## ADDENDUM | No. 1

PROJECT	<b>Madison Service Line – Segment 2/3A between Crooks and Colton, South Dakota</b>		
BID DATE	2:00 P.M.	Local Time - Central	April 26, 2022
BID LOCATION	Lewis & Clark Regional Water System Office 46986 Monty Street, Tea, SD 57064		
ISSUE DATE	4-19-22		
NOTICE	Failure to acknowledge all addenda in the BID may cause rejection of the BID. See Instructions to Bidders.

SHEET No.: 24

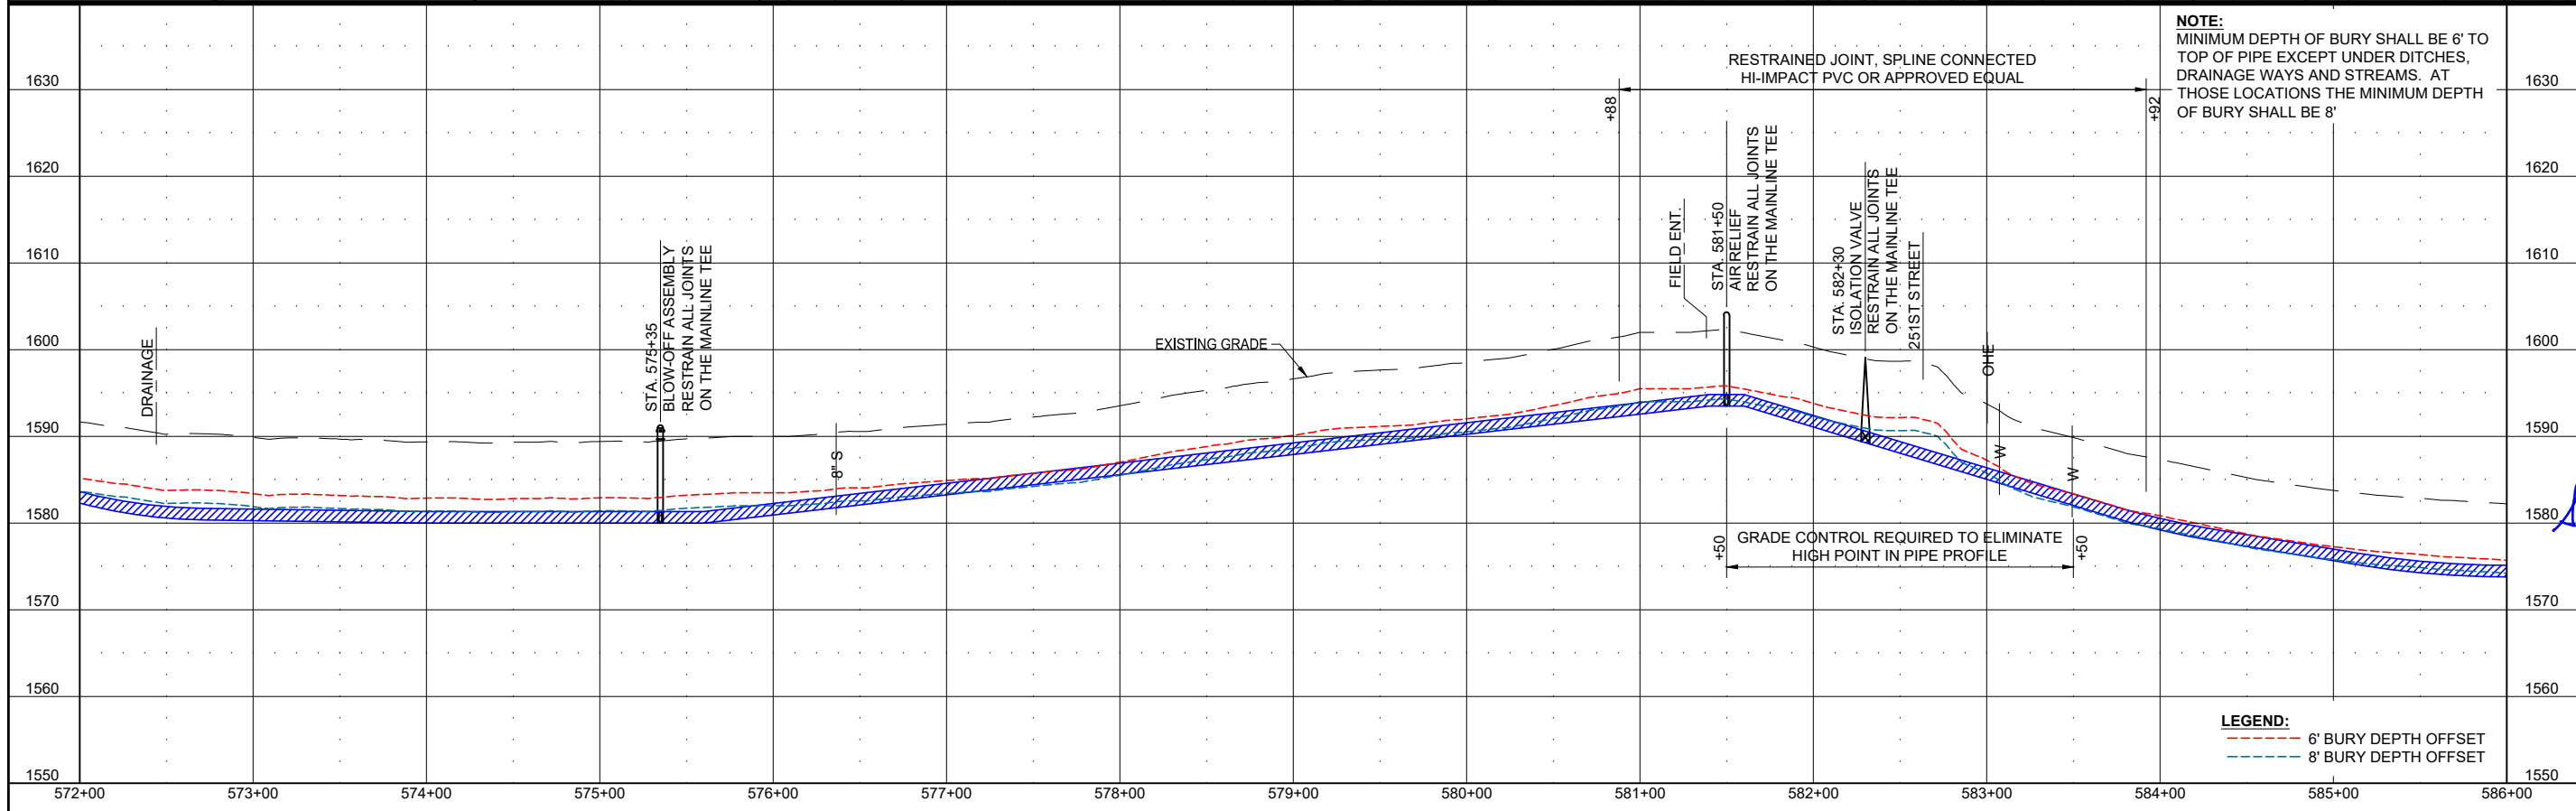
### Drawing Sheet 24.

DELETE the previous Sheet 24 dated 3-28-22, and REPLACE with the attached Sheet 24, Rev. No. 1 dated 4-19-22 in its place.

This drawing sheet has been added to indicate the additional note.

**NOTE:**  
CONTRACTOR SHALL EXPOSE ALL UTILITIES A MINIMUM OF TWO WEEKS PRIOR TO CROSSING TO CONFIRM TYPE, SIZE, LOCATION, ELEVATION AND TO COORDINATE CROSSING. INCIDENTAL TO PIPELINE INSTALLATION.

SHEET No. : 47

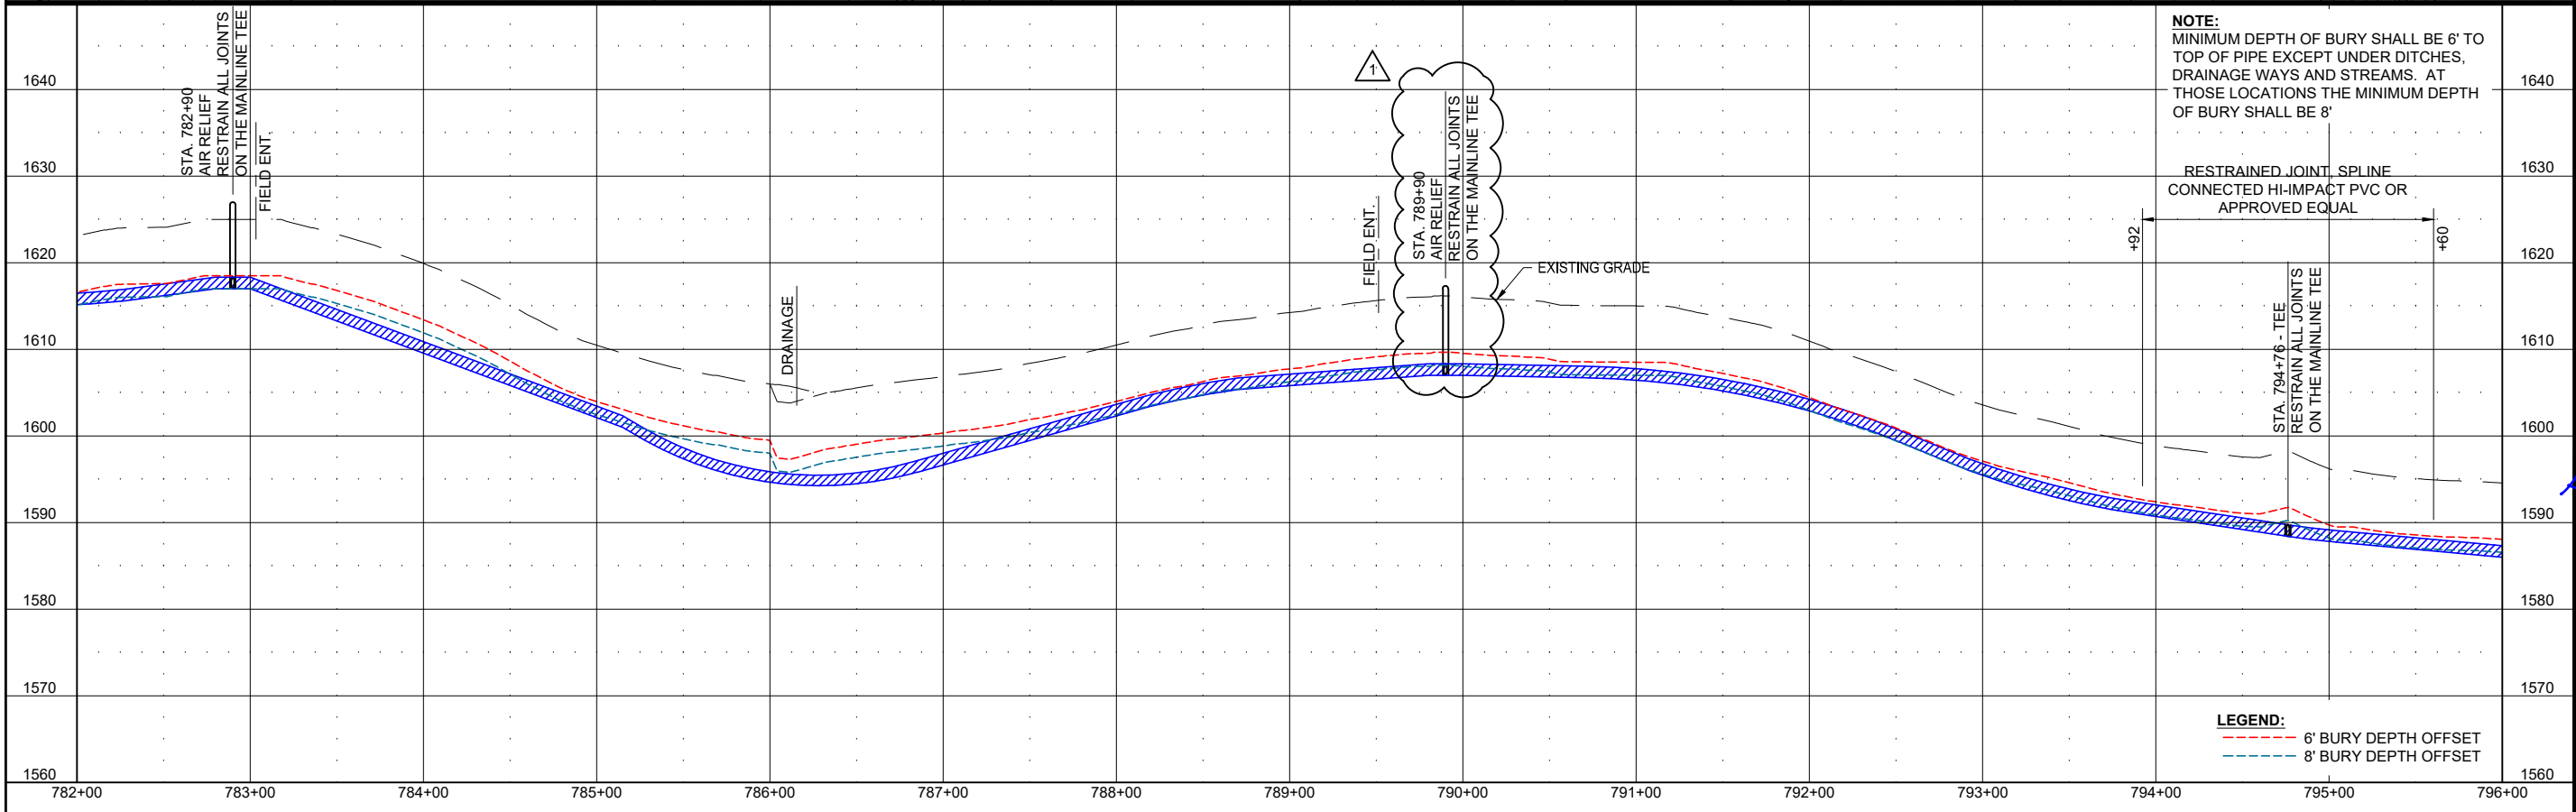
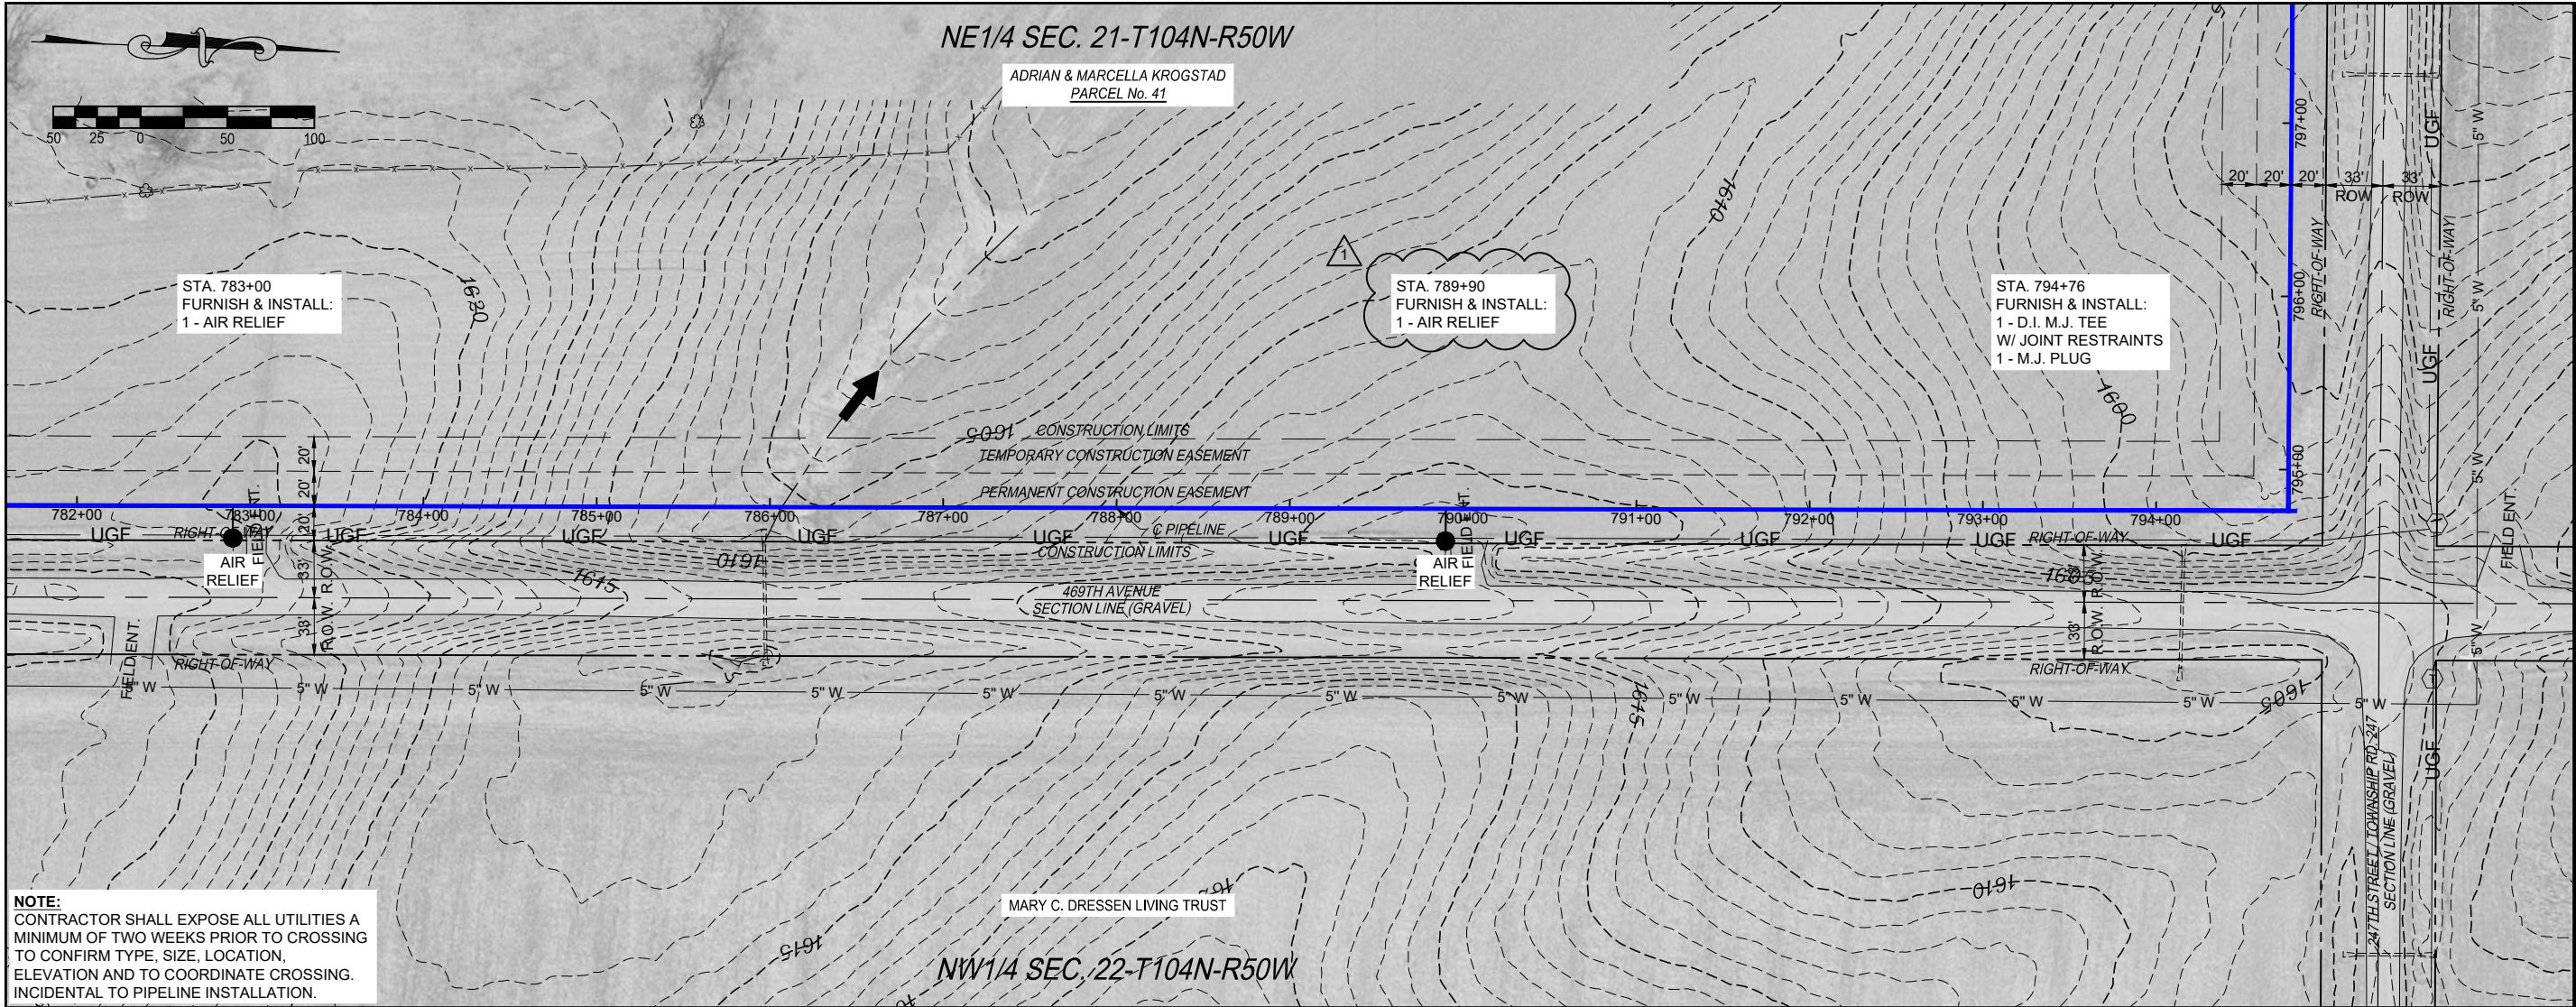
### Drawing Sheet 47.

DELETE the previous Sheet 47 dated 3-28-22, and REPLACE with the attached Sheet 47, Rev. No. 1 dated 4-19-22 in its place.

This drawing sheet has been added to correct misspelled word.
